PRODUCT TROUBLESHOOTING

AC-0001-CSR

Product: Window Air Conditioners

Applicable Models: HWR08XC6, HWR08XC6-T, HWR10XC6, HWR10XC6-T

Fig. 1 AC-6100-39 Screen-Accordion

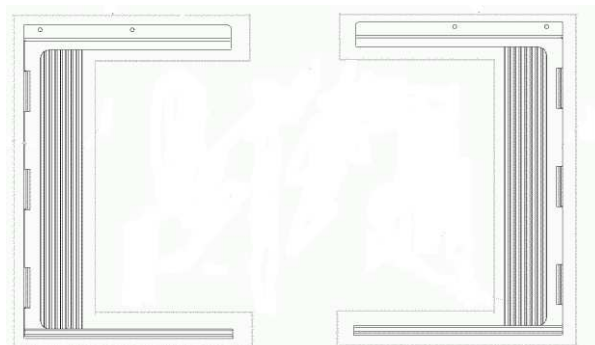
Symptom: Side curtains provided with the unit doesn't extend to the desired length of 36 inches as described on the manufacturers' box.

Solution: Replacement curtains shown in (Fig. 1) can be ordered for customers. Part number for curtains is **AC-6100-39**. This should extend to 36 inches.
